ADDENDUM No. 1

RFP No. 2023-0010

Project Name: Airbus Engineering Roof Repairs

1 CURB FLASHING DETAIL
SCALE: N.T.S

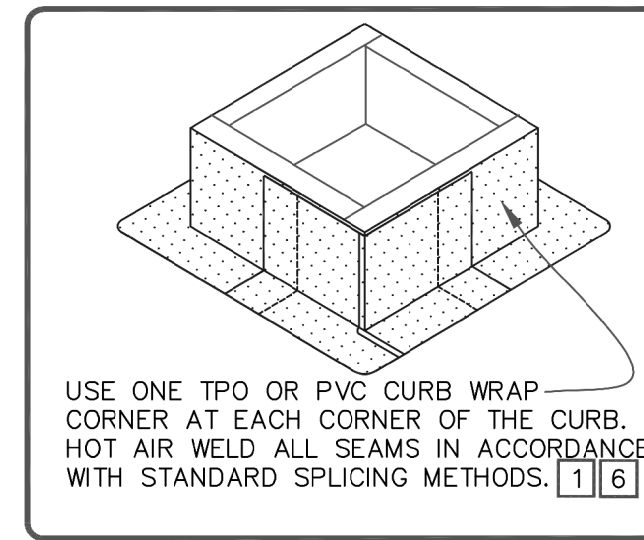
Question – After looking at the roof yesterday, I have a question about the large HVAC units on each roof. It appears that the curbs were flashed prior to the units being placed on the curbs. With the way the units are set now, we will not be able to extend the membrane high enough on the curb to reach manufacturer's requirements of 8" above the roof surface without the units being lifted. This will require an HVAC subcontractor and of course the units being shut down for at least a day to disconnect, raise, flash, and re-connect.

Answer - If there is a requirement to shut down the HVAC system at any time, the work will need to be coordinated with MAA and Airbus. The work shall be performed during non-working hours (i.e., after 5 pm or during the weekend).

1 PARAPET COPING WITH CONTINUOUS MEMBRANE TIE-IN
SCALE: N.T.S

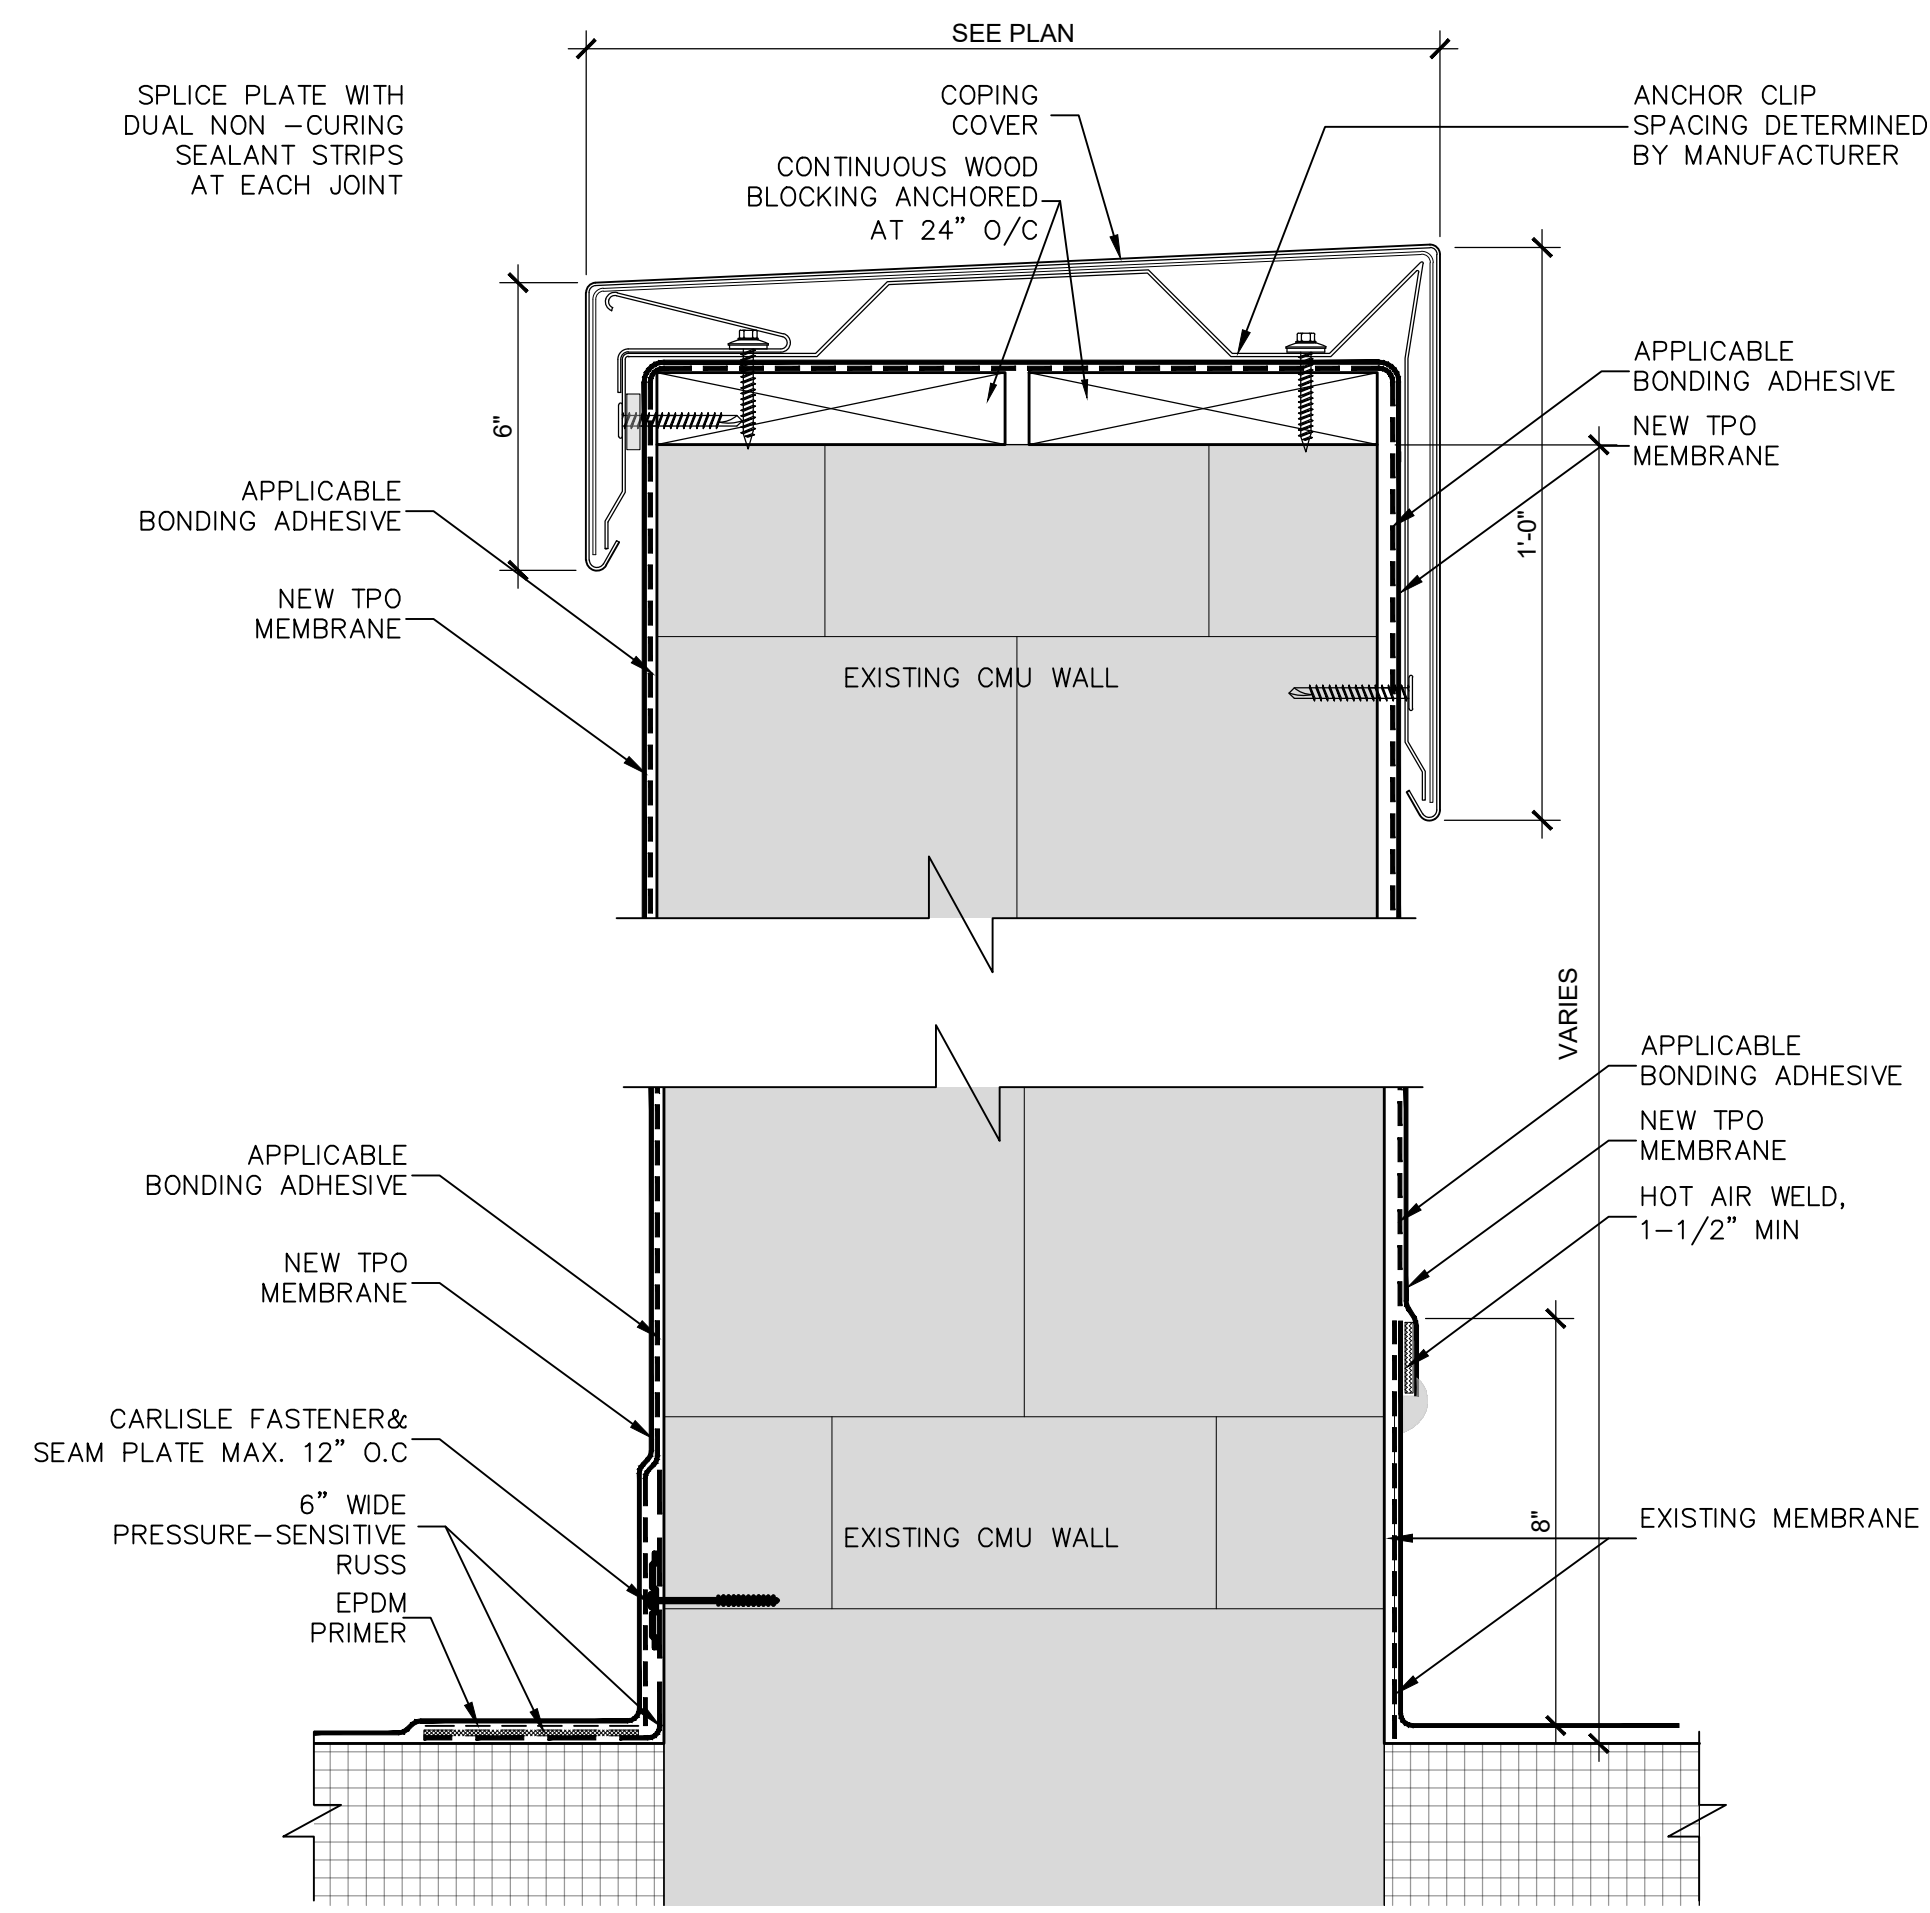
1. The proposal deadline for this RFP has been extended from July 27, 2023 to **August 3, 2023**. The deadline to submit questions regarding this RFP has been extended from July 18, 2023 to **July 27, 2023**.
2. Specifications - Section 2.06.C.1 Metal Flashing and Membrane Terminations, Coping

As referenced in detail 1/A500.1 at the specified locations in the provided detail drawings; install continuous lumber blocking atop the parapet wall to provide an anchor point for the new coping clips/ fasteners, install new fully adhered TPO membrane from the base of the replacement area up and over the parapet walls then extending to the opposite existing base leaving a 1 ½" overlap on each side to be heat welded to the existing membrane. Heat welding should be performed per the manufacturer recommendations. Ensure the existing membrane remains to extend vertically up the parapet wall by approximately 8" prior to installation/securement of the new TPO membrane. See provided detail for specific fastener spacing.
